# BID Addendum No. 4

March 19, 2021  
Bedford Fire Headquarters  
550 Old Post Road  
Bedford, NY 10506

***Note:** This addendum forms a part of the Contract Documents for the above project and modifies it with amendments and additions noted below.*

- DO NOT SCALE THIS PLAN. SEE ARCH. FOR ALL DIMENSIONS AND ELEVATIONS.
- ROOF DECKING SHALL BE 1-1/2" TYPE B STEEL ROOF DECK (22 GAGE) WITH 5/8" PLYWOOD SHEATHING ON TOP.

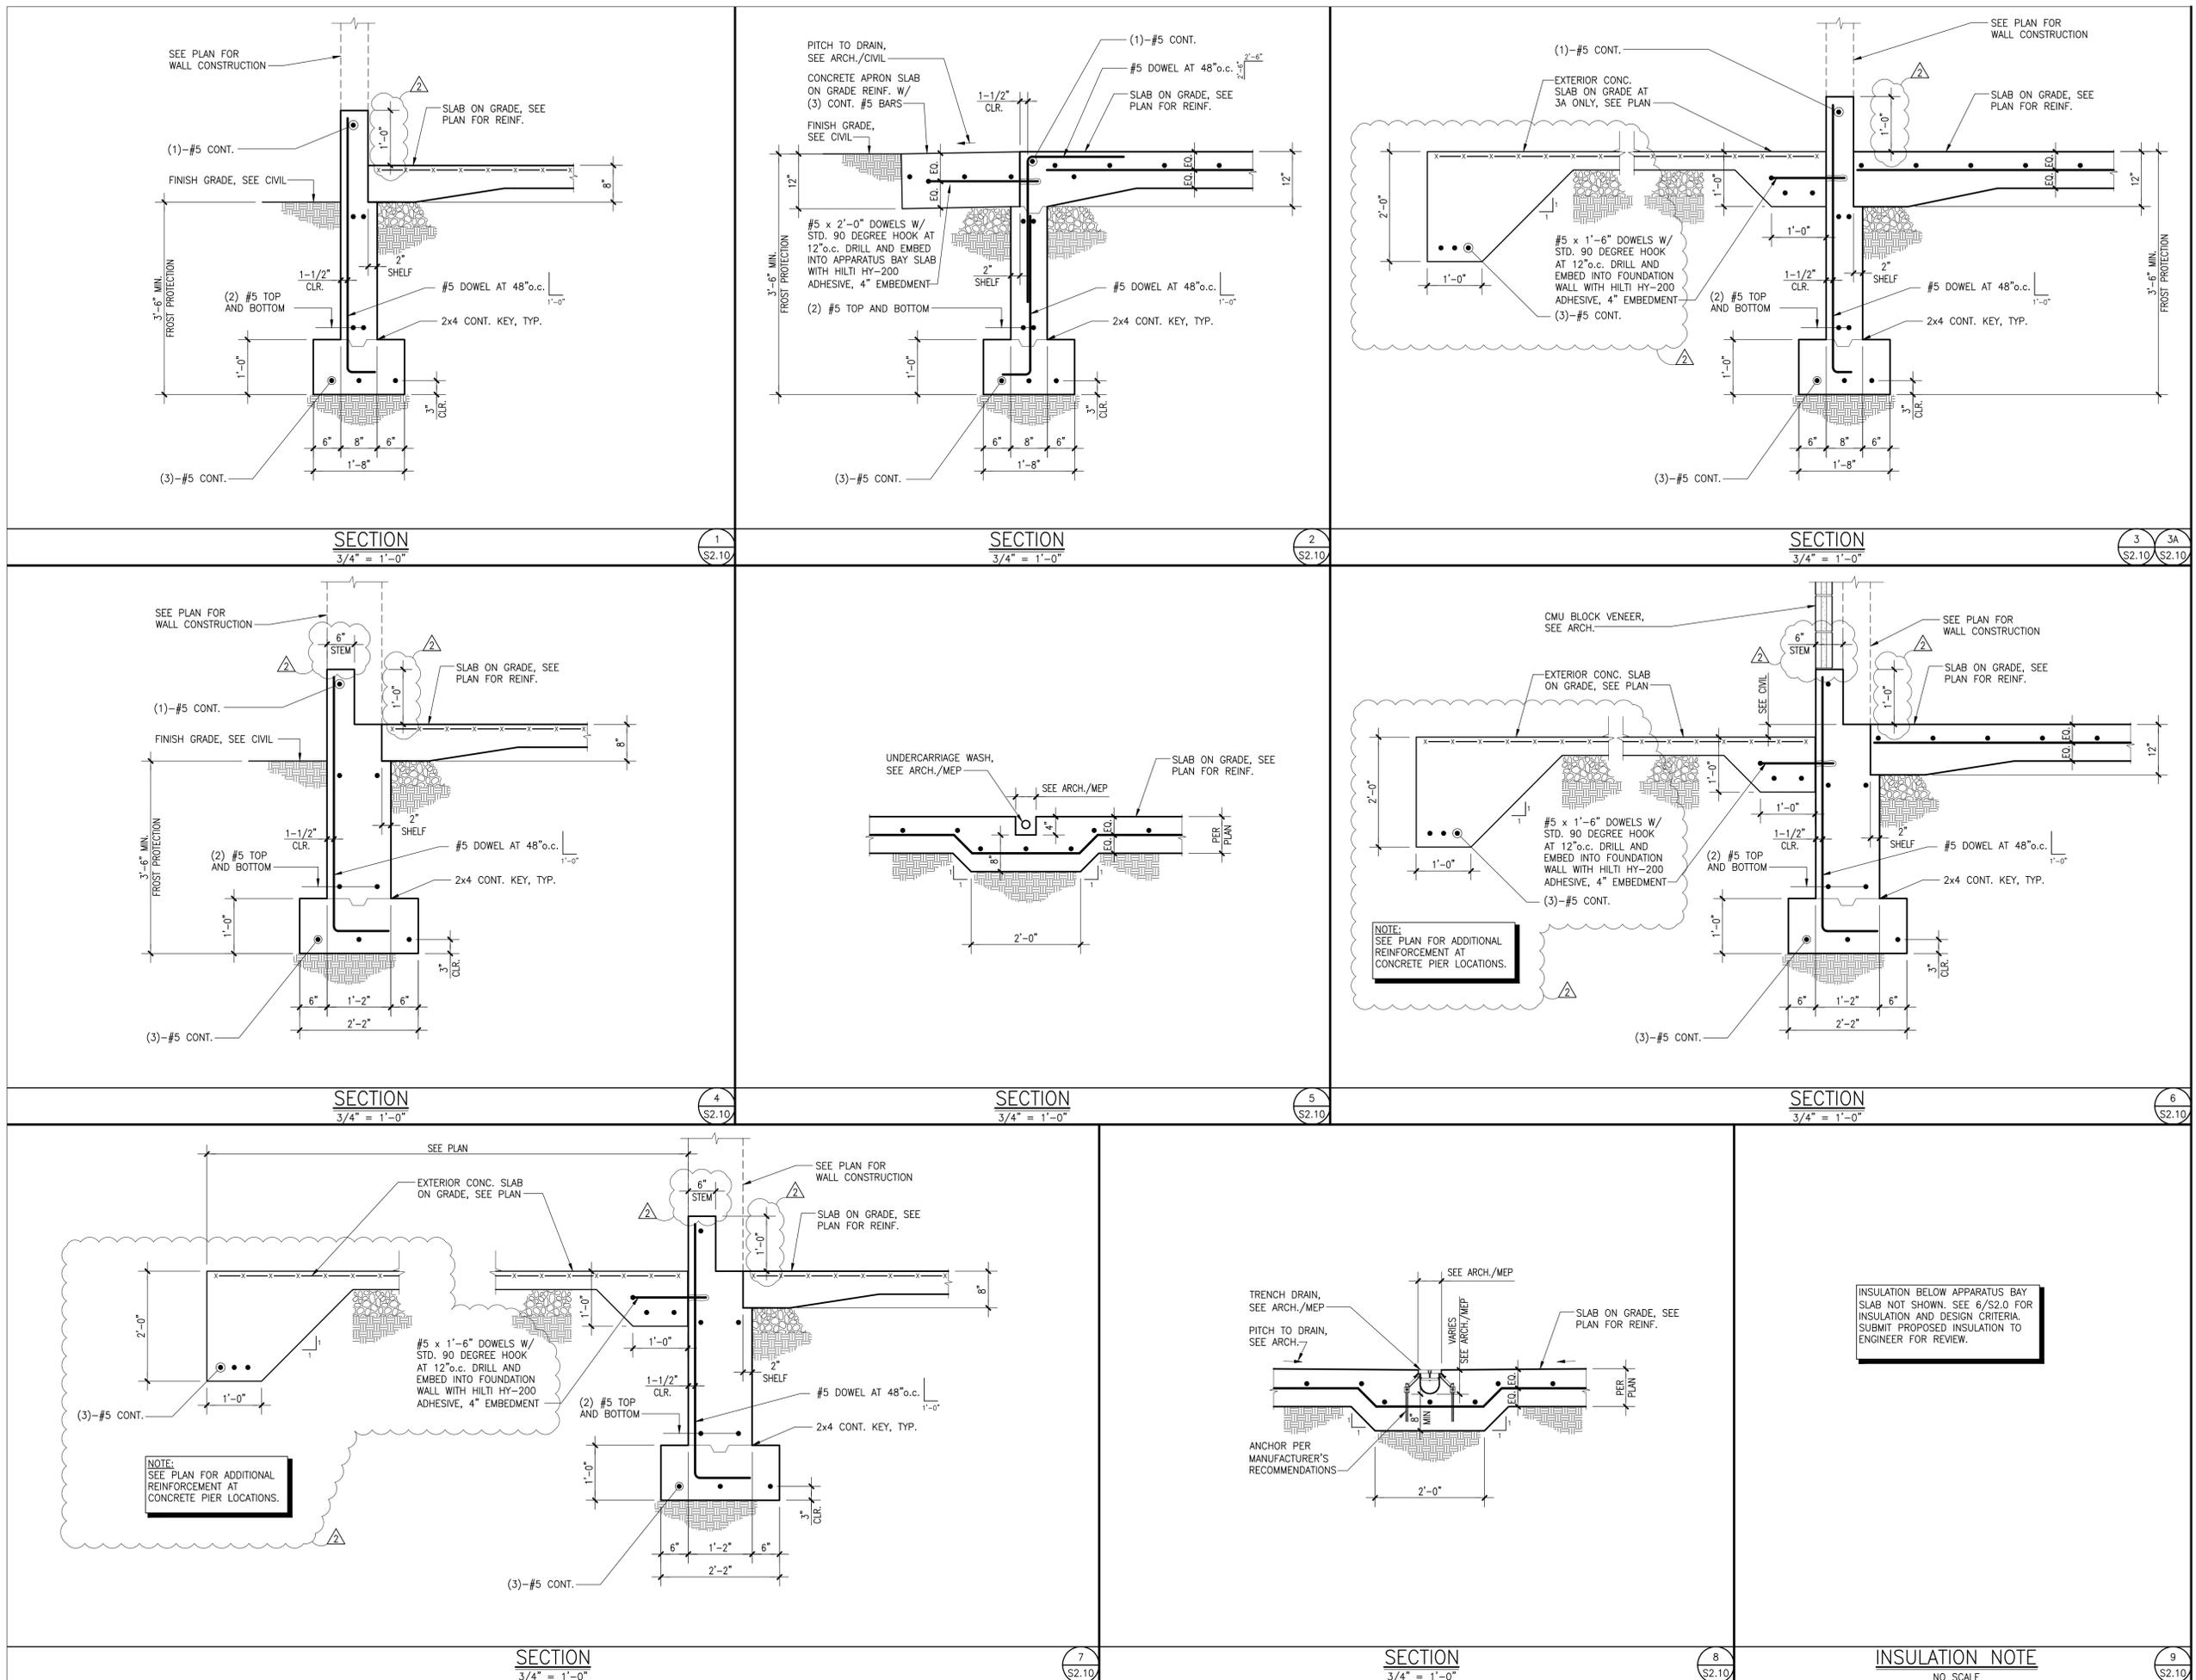
3. Drawing S1.0- Delete drawing S1.0 in set and replace with the attached revised Drawing S1.0.
4. Drawing S1.1- Delete drawing S1.1 from Addenda # 3 and replace with the attached revised Drawing S1.1.

Drawing No. P2.1

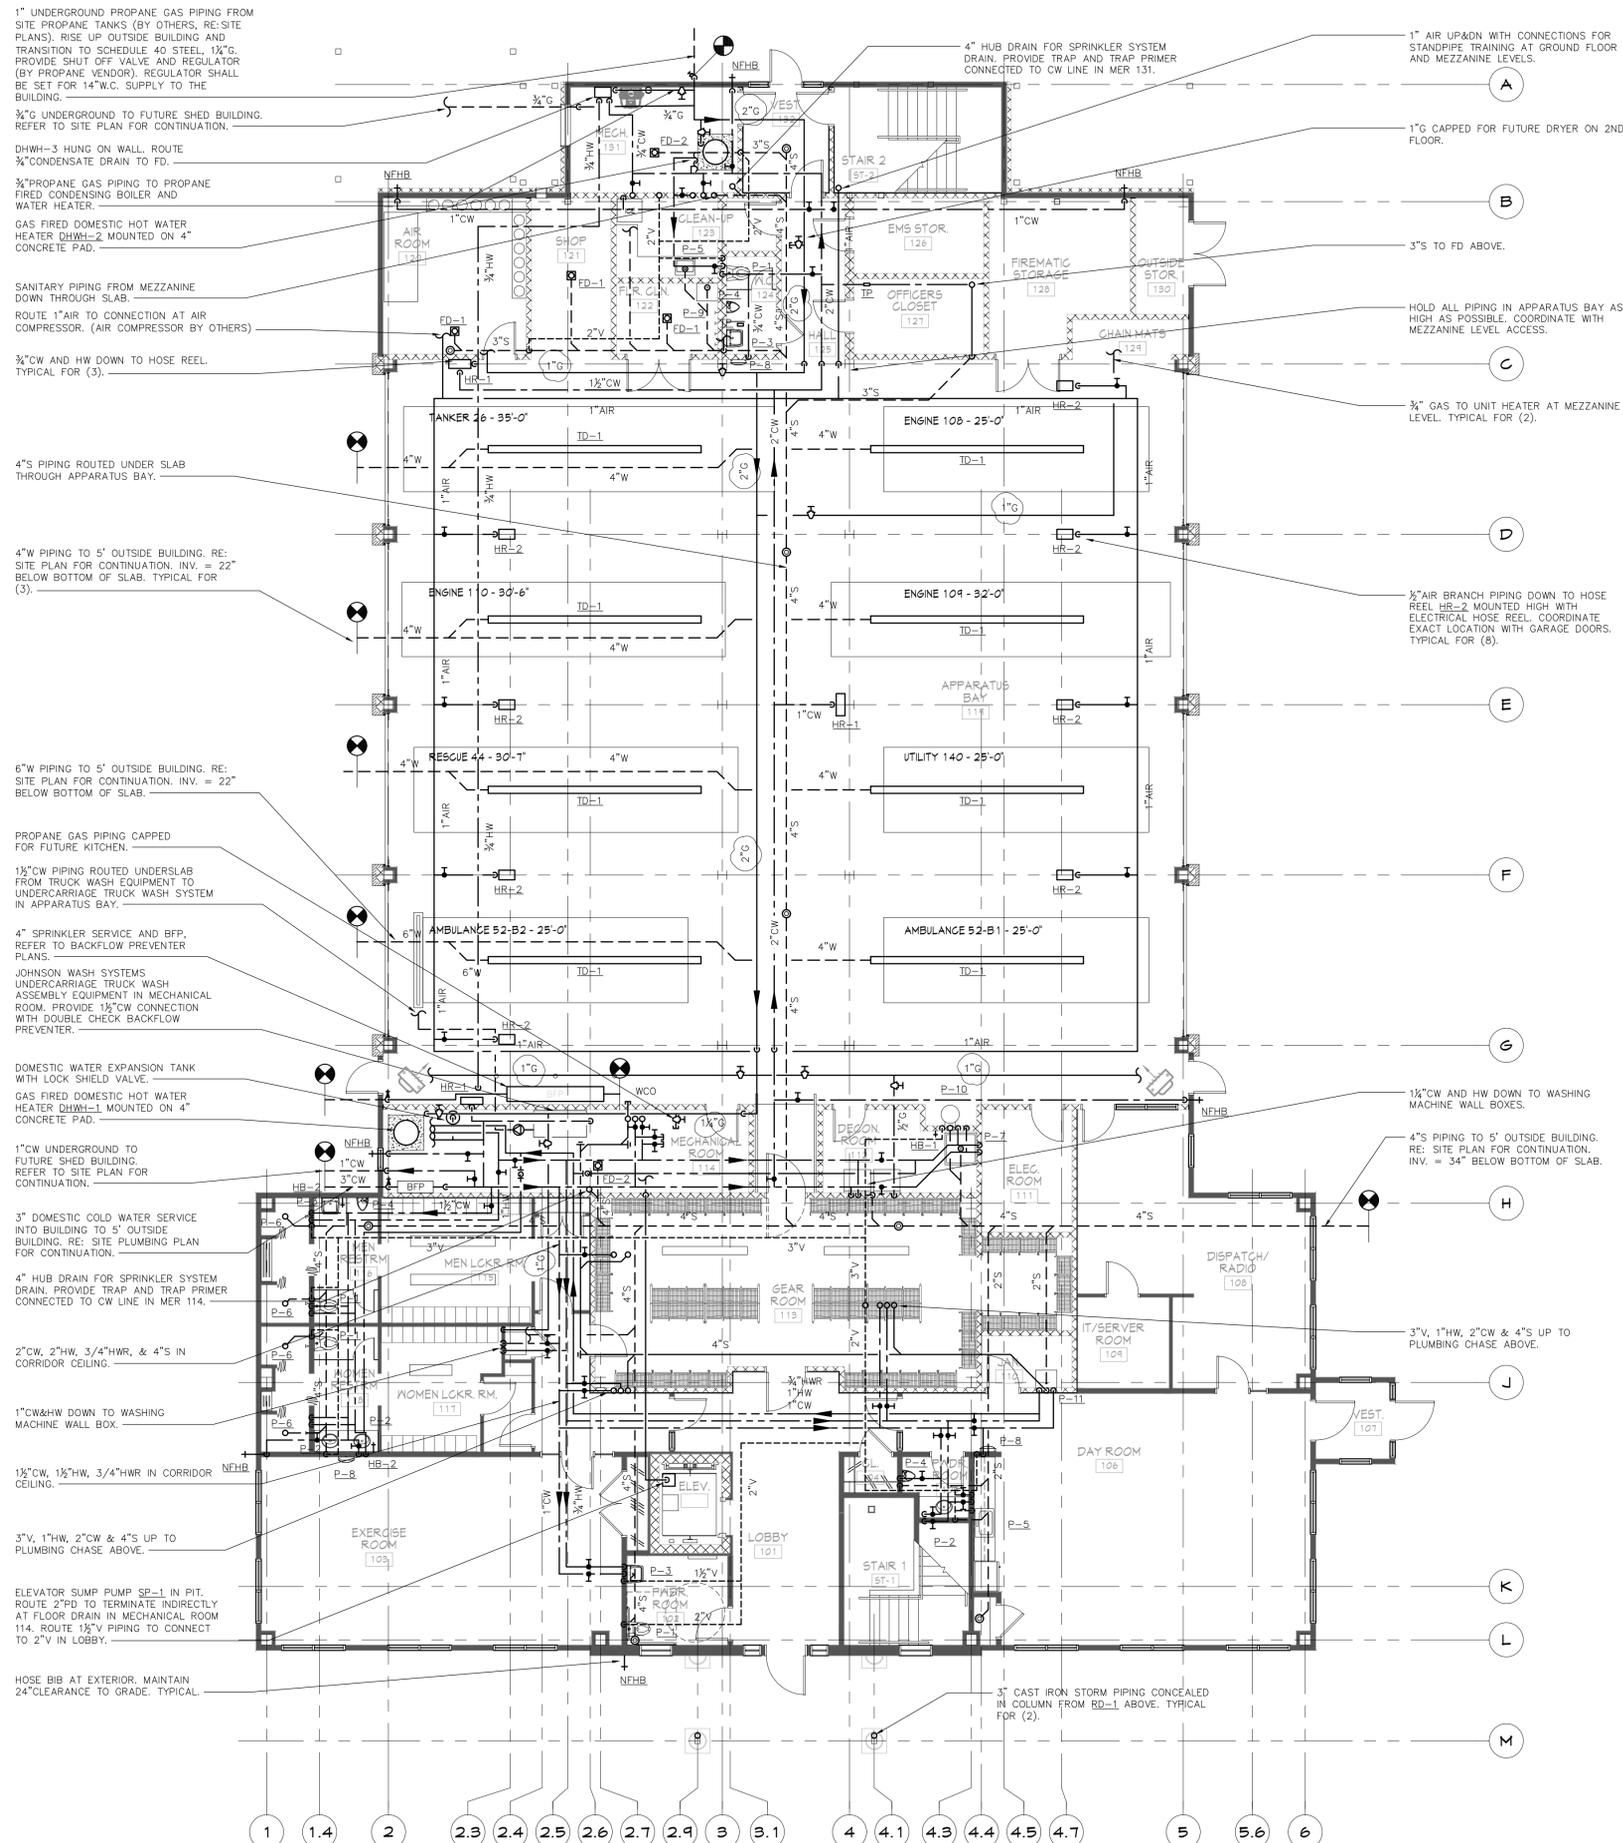
11. Drawing P2.1 - Delete drawing P2.1 in set and replace with the attached revised Drawing P2.1
12. Drawing P5.2 - Delete drawing P5.2 in set and replace with the attached revised Drawing P5.2.

P5.2

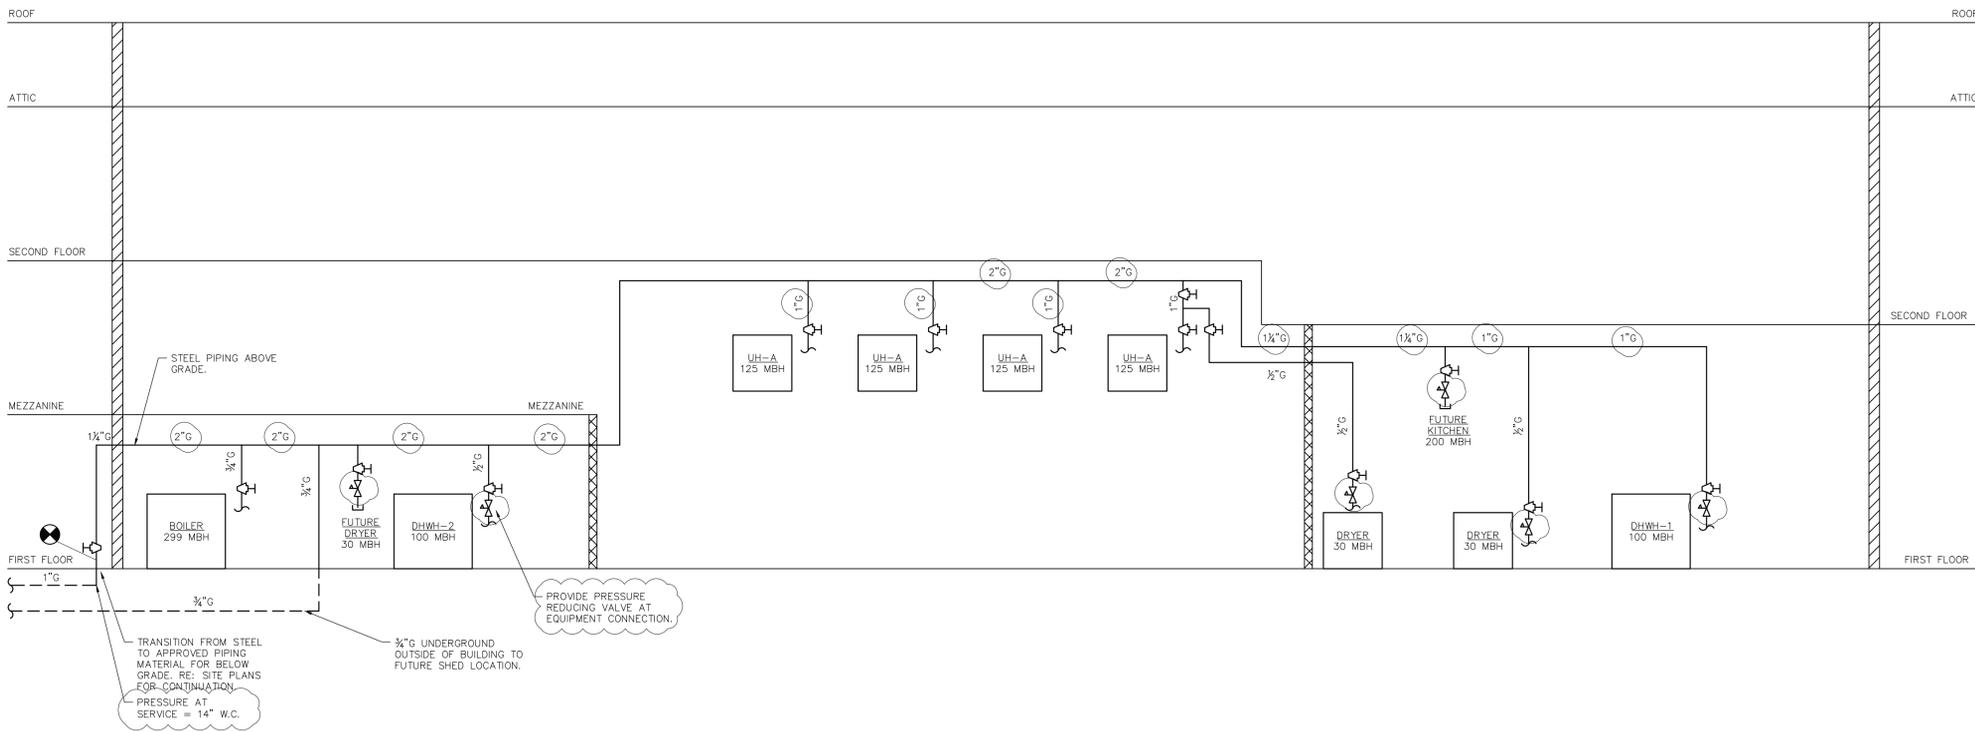
1. Drawing 4/21 - The Underground Gas Piping from the propane tanks to the building will be provided and installed by Owner’s gas vendor. The excavation and backfill for this underground gas line will be by Sitework Contractor # 1.

**Response: Underground Gas Piping from the propane tanks to the building will be provided and installed by Owner's gas vendor. It is no longer part of the Plumbers**

**scope as previously identified in addenda # 2. The excavation and backfill for the underground gas line will be by Sitework Contractor # 1**
